WORKPLAN
FURTHER OFF-SITE GROUNDWATER INVESTIGATION
AT
MW19/HOT SPOT 1

L.E. CARPENTER AND COMPANY
WHARTON, NEW JERSEY
USEPA ID# NJD002168748

October 2000

Response to NJDEP Comments

**MW-19 HOT SPOT GROUNDWATER CONTOURS AND
FLOW DIRECTION FOR JANUARY 2000**

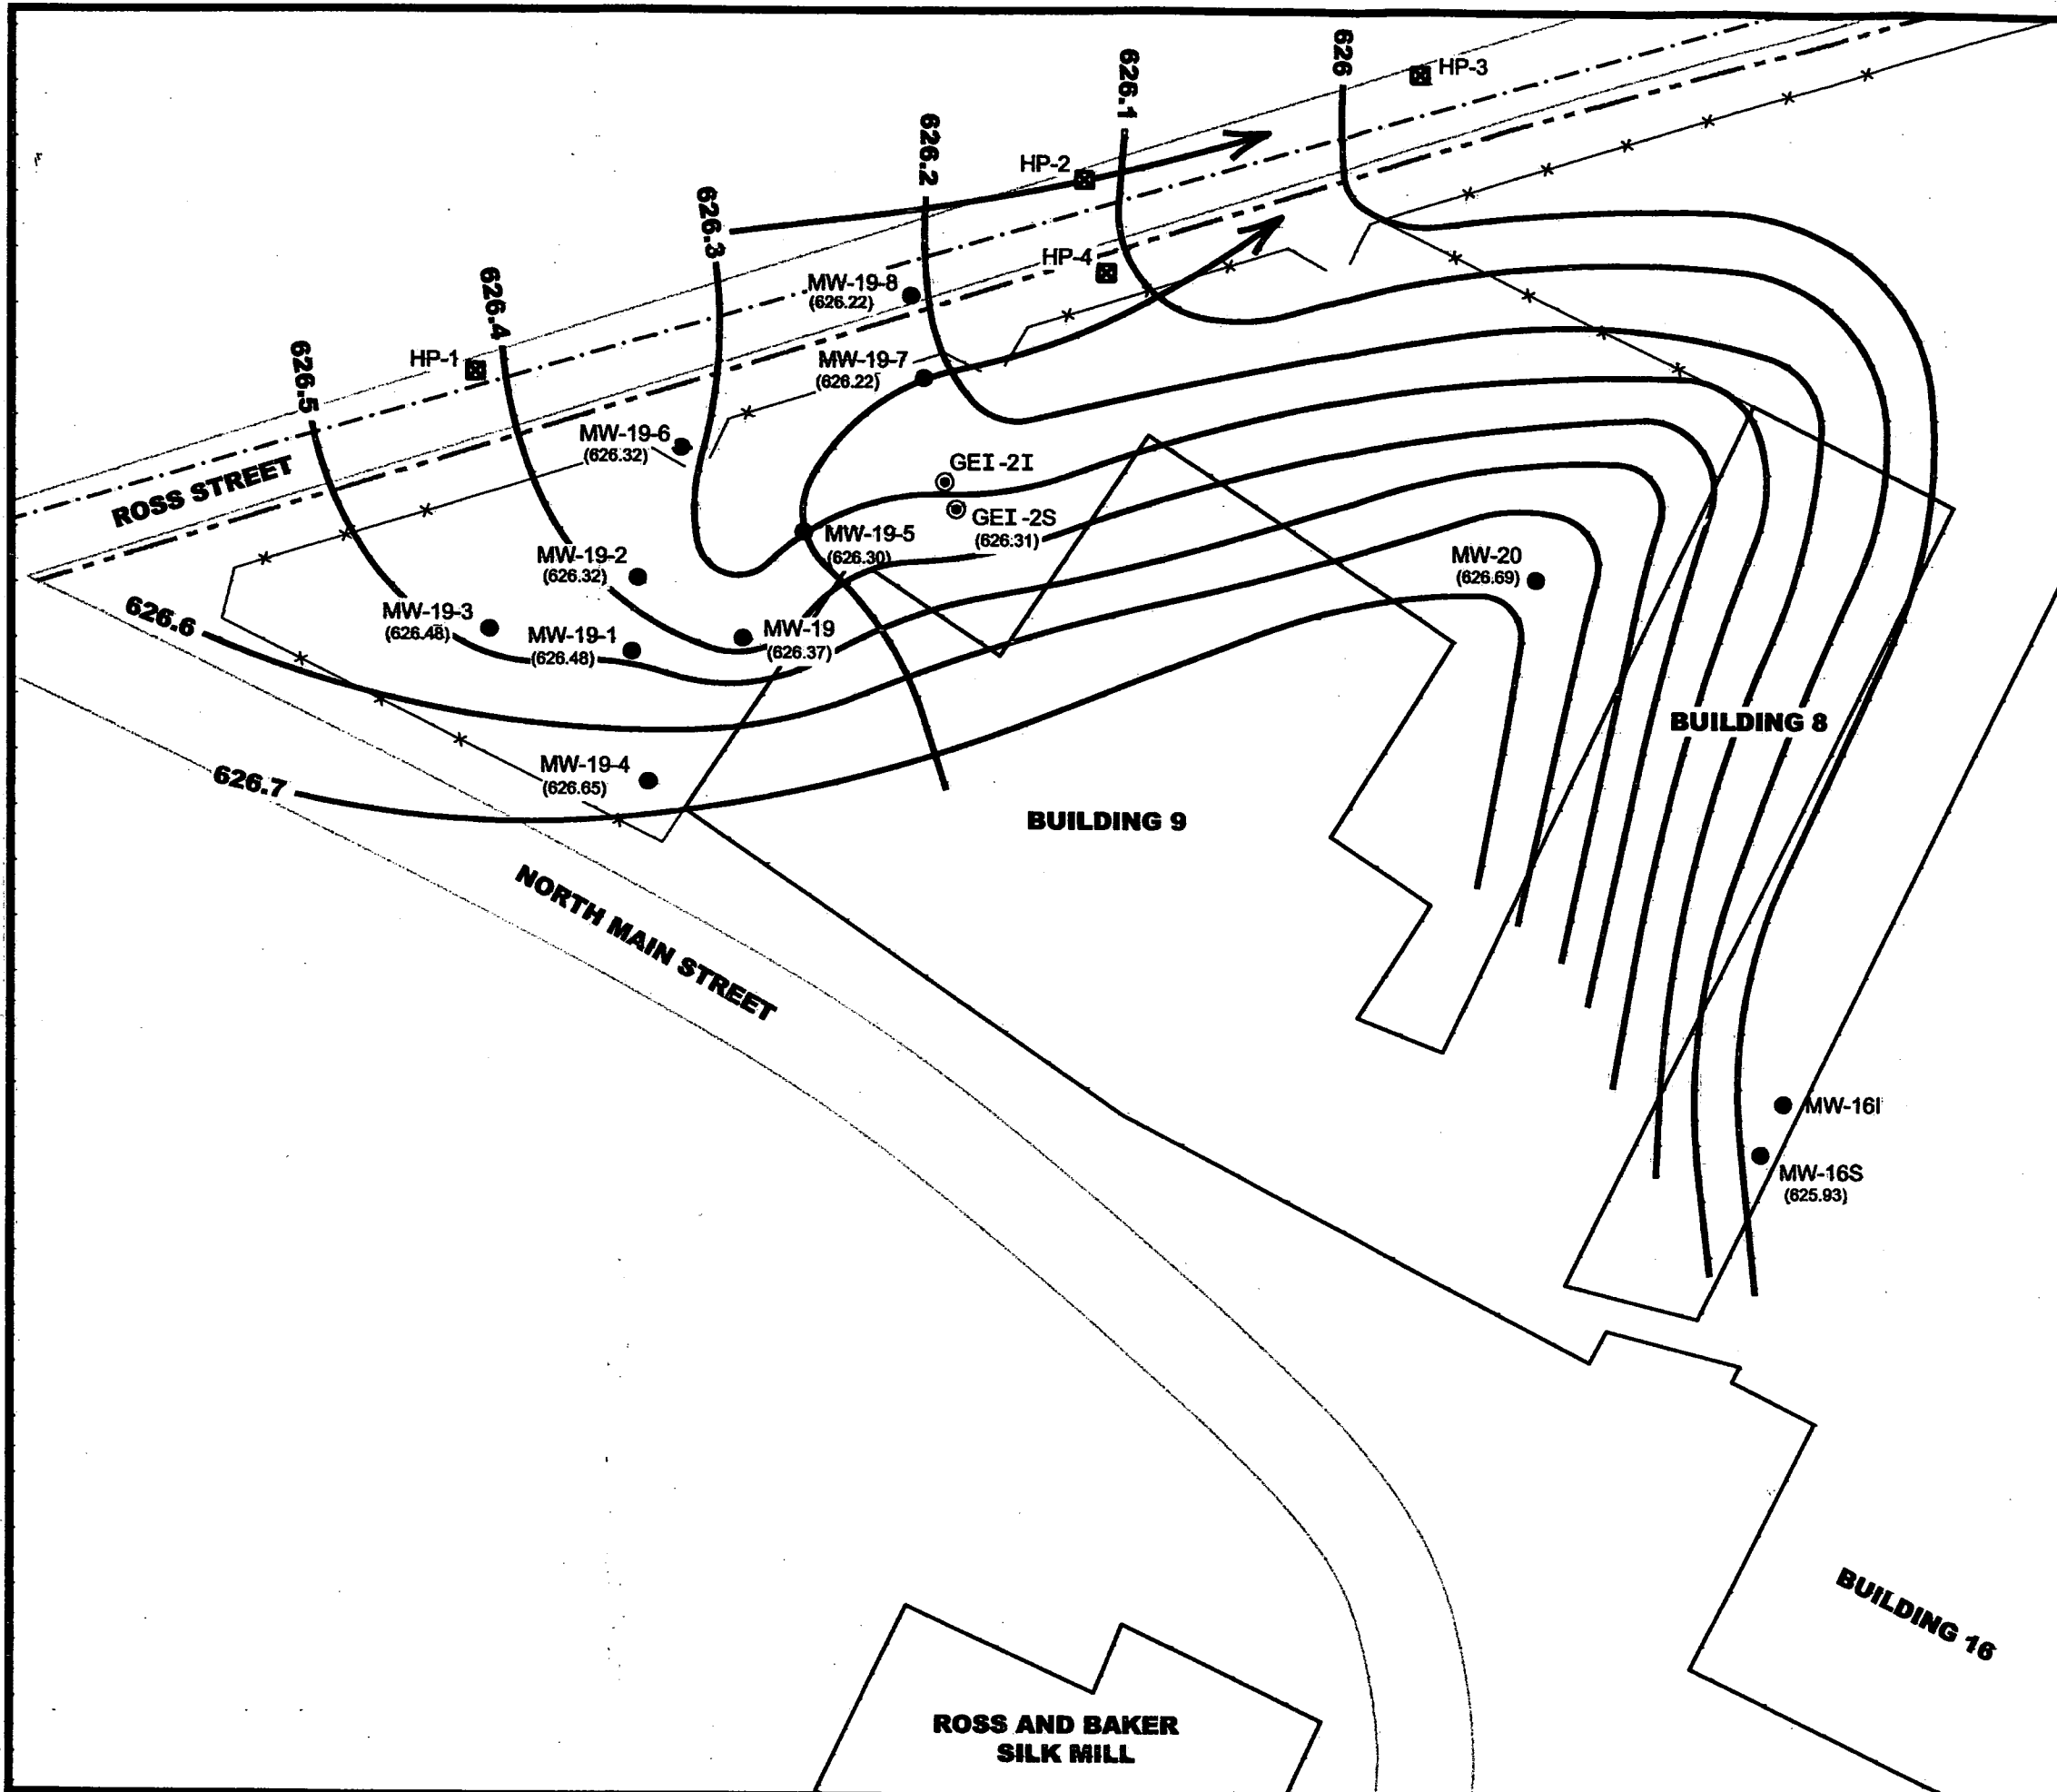
1. It is unclear from Figure 1 what effect the sewer line has on the shallow ground water flow. The ground water flow regime is depicted without data. No ground water elevations are available past the property line on Ross Street or past MW-19-8. Also, seasonal ground water variations most likely will significantly alter the depicted flow regime. Accordingly, the ground water flow depicted in this figure is speculative/interpretive. Please explain how the flow map in this figure is representative of site conditions.

1. For convenience, we have reproduced herein Figure 1 from our May 15 letter as Figure 2. The sewer line's effect on groundwater flow can be visualized clearly by the bend of groundwater contours northwards. The data that supports these contours were included on the original Figure as shown on Figure 2. The groundwater elevations from MW-19-5, MW-19-6, MW-19-7, and MW-19-8 are the controlling points that make the groundwater contours bend to the north, roughly perpendicular to Ross Street and the buried regional interceptor sewer line. While there is some interpretation in the details of the elevation contour placement, we have not been able to create an alternative interpretation that would allow contaminants in the MW-19 area to travel northwards. We have also included groundwater elevation contours for April 2000 (Figure 3) and July 2000 (Figure 4). All of

the groundwater contour maps account for the potential effect that seasonal fluctuations of groundwater may have on the flow pattern in this area, however, there is no significant change in the pattern of groundwater contours. The data continue to demonstrate that shallow groundwater flows northeasterly towards and then parallel to the regional sewer, and that groundwater cannot migrate across Ross Street under the residences to the north.

PROPOSED OFF-SITE MONITORING WELLS

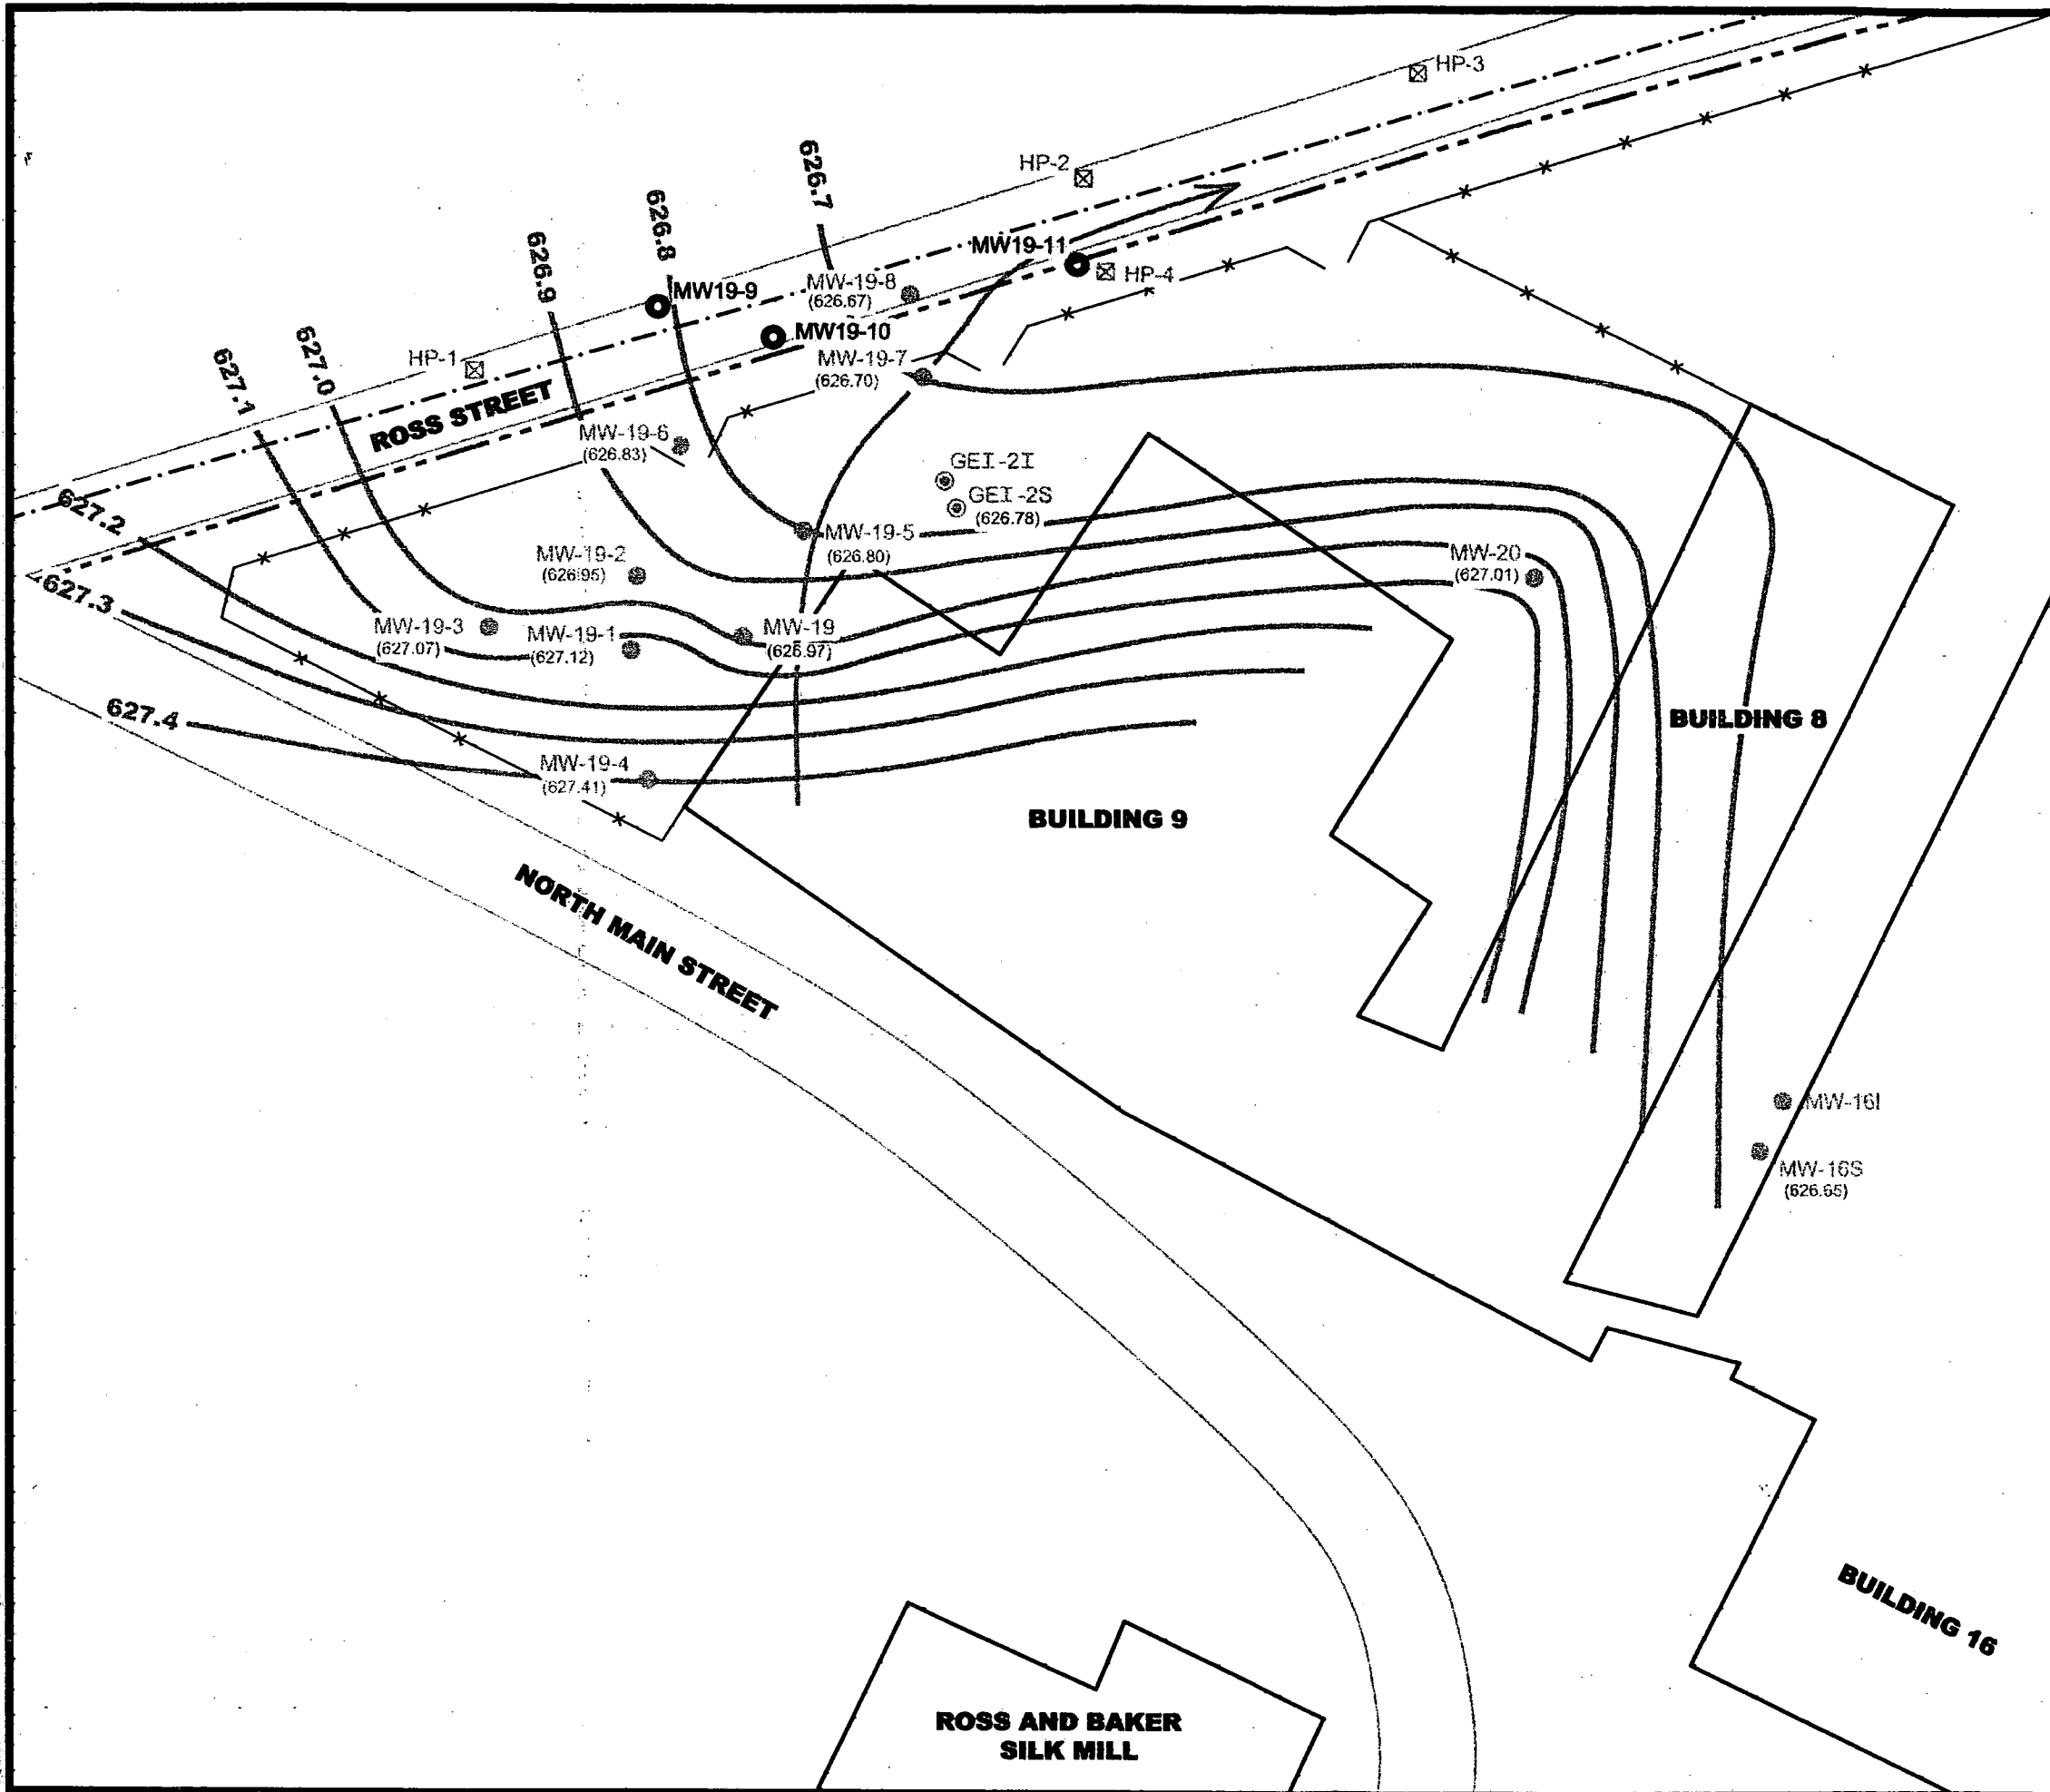
2. If the revised ground water contours provided in Figure 2 and the explanation that the sewer line intercepts ground water flow are in fact correct, a clean zone boundary for BTEX contamination has not been established. The ground water contours indicate MW-19-7 to be the most down-gradient monitor well, although BTEX levels exceed Ground Water Quality Criteria in this well.

3. The document states that the water sample collected from HP-4 confirms that no constituents of concern were detected in shallow ground water downgradient of MW-19-7. HP-4 was a hydropunch location sampled on only one occasion, over one year ago. The ground water sample from this temporary well location was for screening

purposes only and not to be used to confirm ground water quality from a migrating plume over one year later. Based on the elevated levels of toluene, ethylbenzene, and xylene at MW-19-7, it has been documented that these compounds exceed the Ground Water Quality Criteria. Therefore, horizontal delineation has not been established.

Second, if the sewer line is acting as a preferred pathway, as claimed, it is also a preferred pathway for contaminant transport as well. This has been overlooked, thus contaminants migrating along the pathway may not be apparent in MW-19-8. Therefore, EPA reaffirms its previously stated position that delineation is not complete, and an additional monitoring well is needed.

As discussed during the July 31, 2000 conference call, a minimum of one monitoring well must be installed north of the sewer line. In accordance with the September 26, 1986 Administrative Consent Order, paragraphs 18 and 19, a work plan must be submitted within sixty (60) days from the receipt of this letter addressing the above

2. NJDEP is correct in stating that groundwater monitoring well MW-19-7 is at the leading edge of groundwater contamination (furthest downgradient), and the total BTEX concentrations are above the Groundwater Quality Criteria. The "clean zone" was previously defined with data from hydro-punch location HP-4 (VOCs were not detected), which was located about 100 feet further downgradient from MW-19-7. However, as NJDEP suggests, this point cannot be verified any further without a permanent monitoring well. Therefore, we will install a well near HP-4 as shown on Figure 5 that will provide a better definition of the downgradient clean zone.

3. NJDEP again states that screening data cannot be used to confirm groundwater quality over one year after the screening data was collected, and therefore horizontal delineation has not been established. As stated above, we propose to install an additional downgradient well in order to provide a repeatable sampling point for completing the downgradient horizontal delineation.

indicate that minimal, if any, dissolved phase constituents are actually migrating as far as the sewer line, LEC agrees to install an additional well between MW-19-6 and MW-19-8 (Figure 5). This well will provide additional definition of groundwater flow directions and should suffice to verify whether constituents are migrating to the sewer line.

Despite existing data that shows adequate definition of the lateral and vertical extent of contaminants in groundwater, LEC agrees to install the three additional wells (Figure 5) discussed above. However, we must emphasize that the chances of finding significant dissolved phase constituents migrating along the sewer line or under the sewer and across Ross Street are not very probable. If the data collected during completion of this workplan confirms the limited lateral extent and concentrations of the dissolved VOCs and semivolatile organic compounds (SVOCs), LEC will not install any more wells in this area.
